FIGURE C2-1  
 SCENARIO 213: ANNUAL SHADOW FLICKER  
*Expected-Case Scenario*  
*Off-Reservations Receptors*

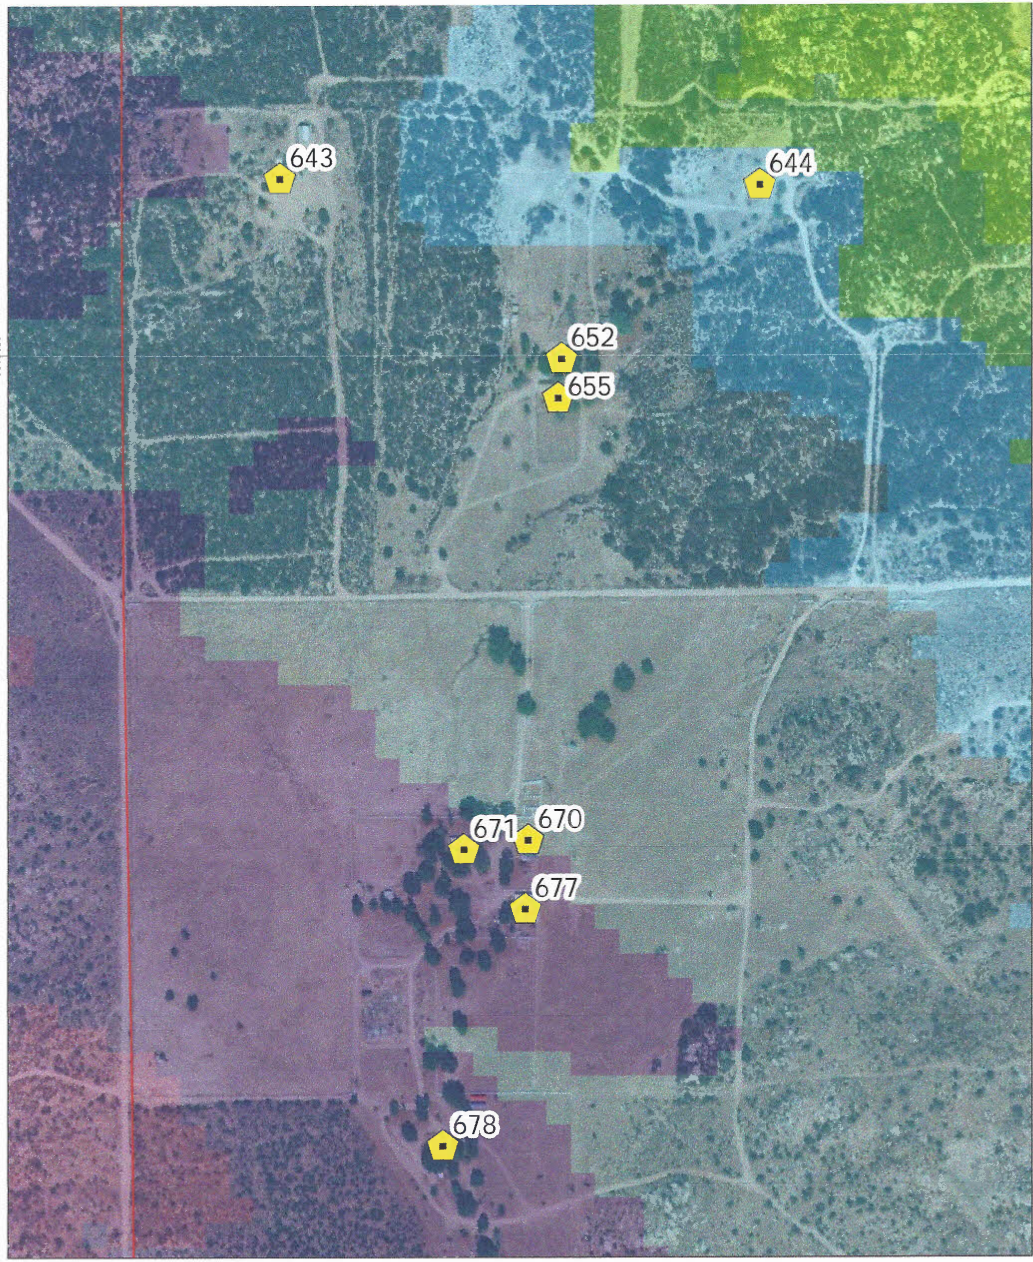
**Appx O Shadow Flicker Analysis: Flawed analysis used smaller turbines than the 4.2 MW turbines already disclosed in this DEIR and the Campo Wind DEIS.**

- ***Figure C2-1<sup>2</sup> Expected –case-scenario Off-Reservation Receptors table at pages 30 and 31 of 34 demonstrates that our occupied homes, farm buildings (#670, 671, 678, 677 & 678), main yard, patio, pastures, pens, and riding arena, will be subjected to between 39-41 minutes per day and 97.3 and 123.20 hours of shadow flicker per year - even though the analysis used shorter 3.83 MW turbines instead of the 4.2 MW turbines documented in the BIA’s DEIS.***
